FOUNDATION PLAN
SCALE: 1/4" = 1'

* PLUMBING & FOUNDATION PLAN *

NEW RESIDENCE
for
LONNIE & TAMMIE
JOHNS

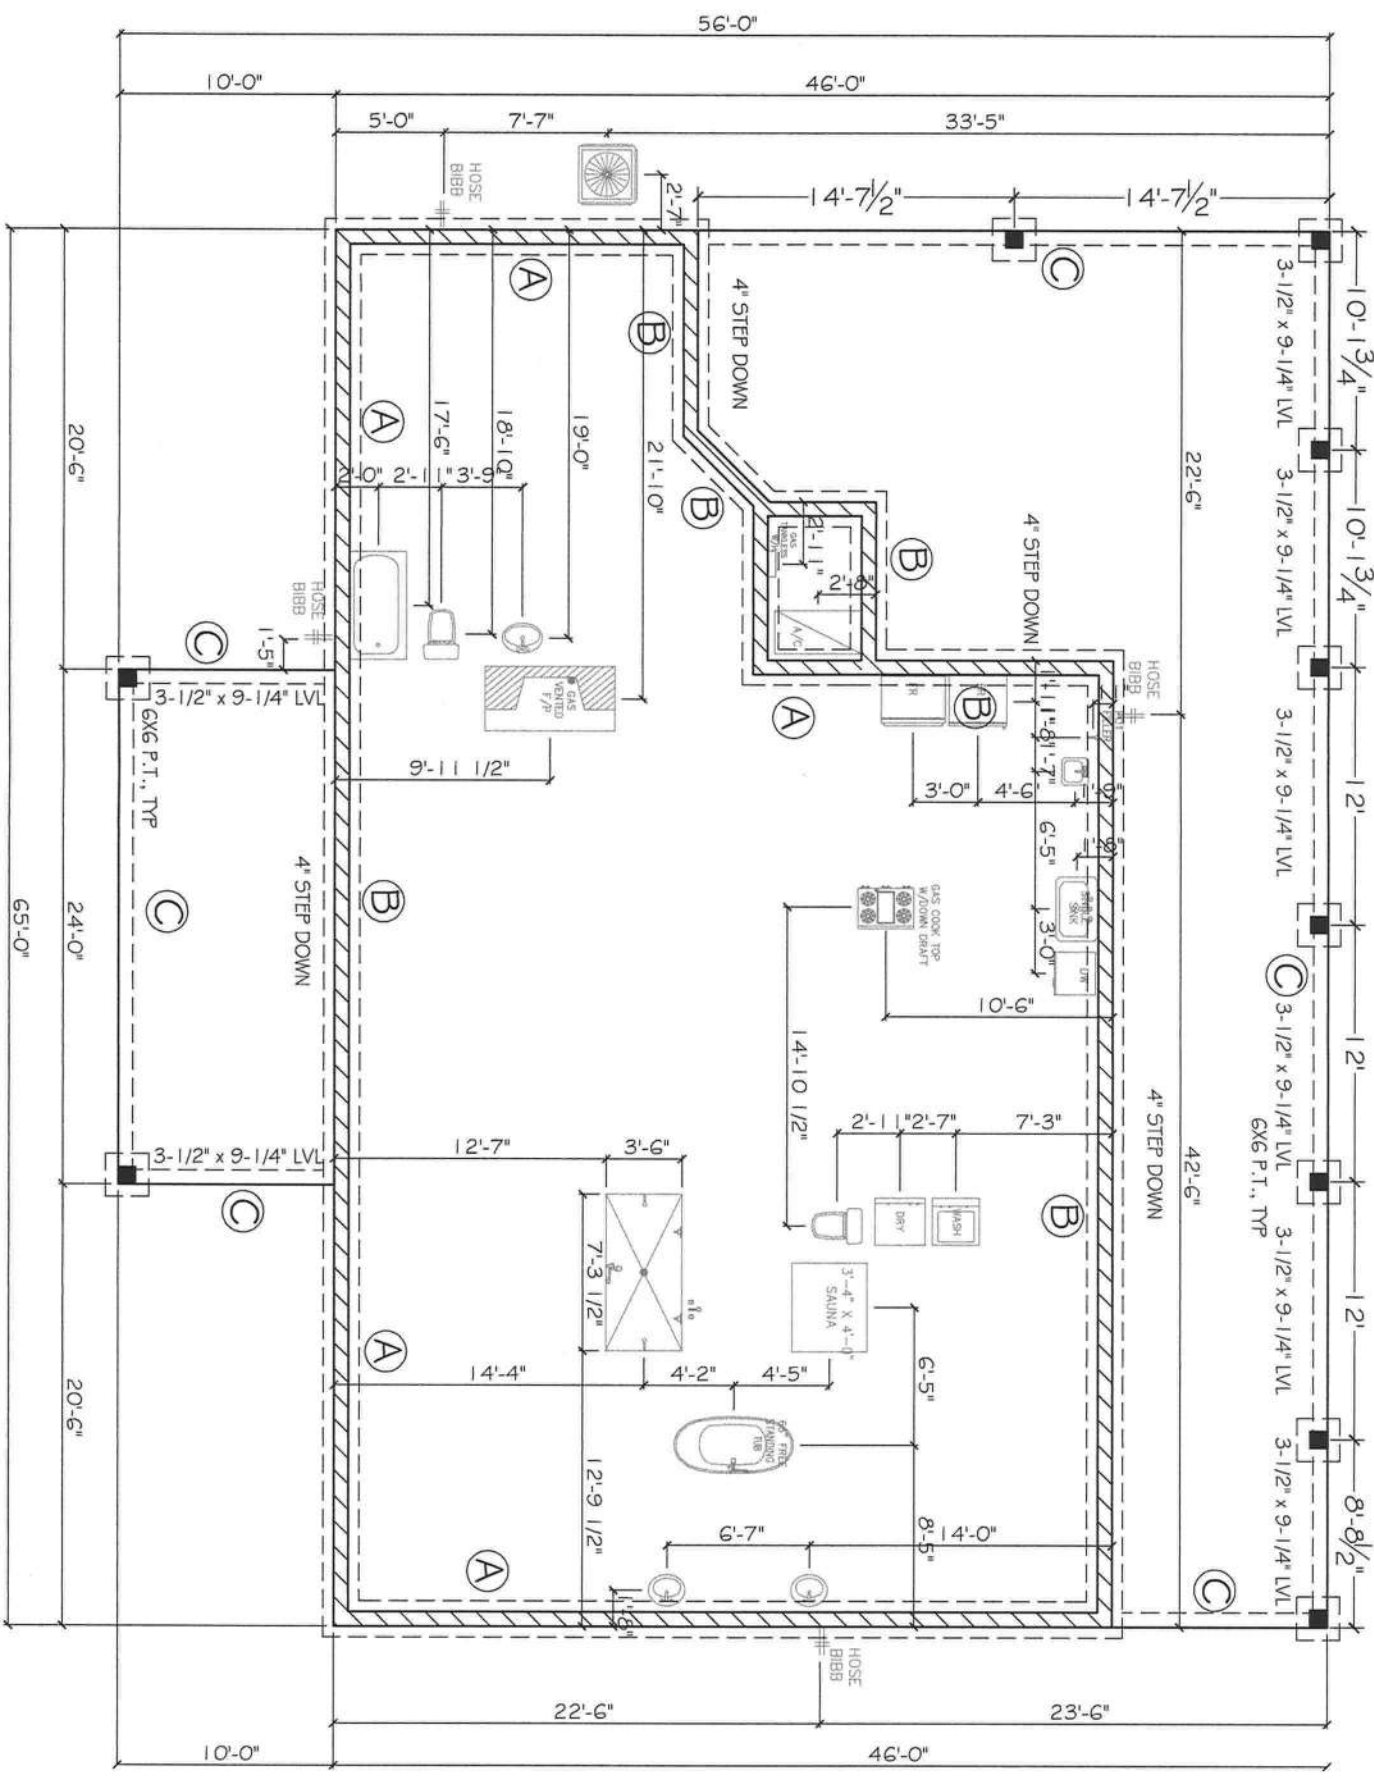
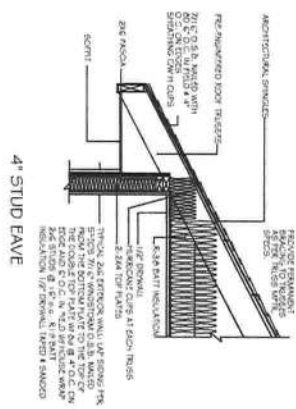
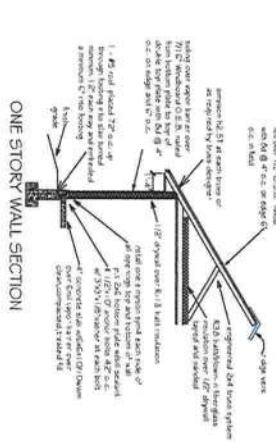
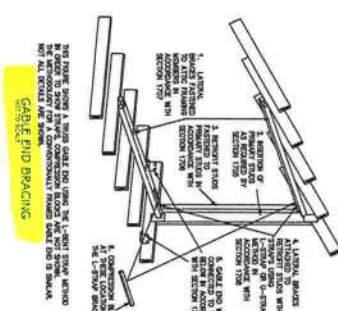
-
- At concrete slab over detail (C1):
 1 - #5 bars extend over slab supports and lap splice.
 1 - #5 bars continue within 25" up and bend outside reinforcing mat 25" at corner (B9).
- FOOTING AT POSTS:**
 2 - #2 @ 1'-0" depth with 3 - #5 bars each way at bottom of 4'-0" x 4'-0" ABSDS base attached to slab using 1/2" x 4" redline anchor.
- C** Woolwich slip detail at post
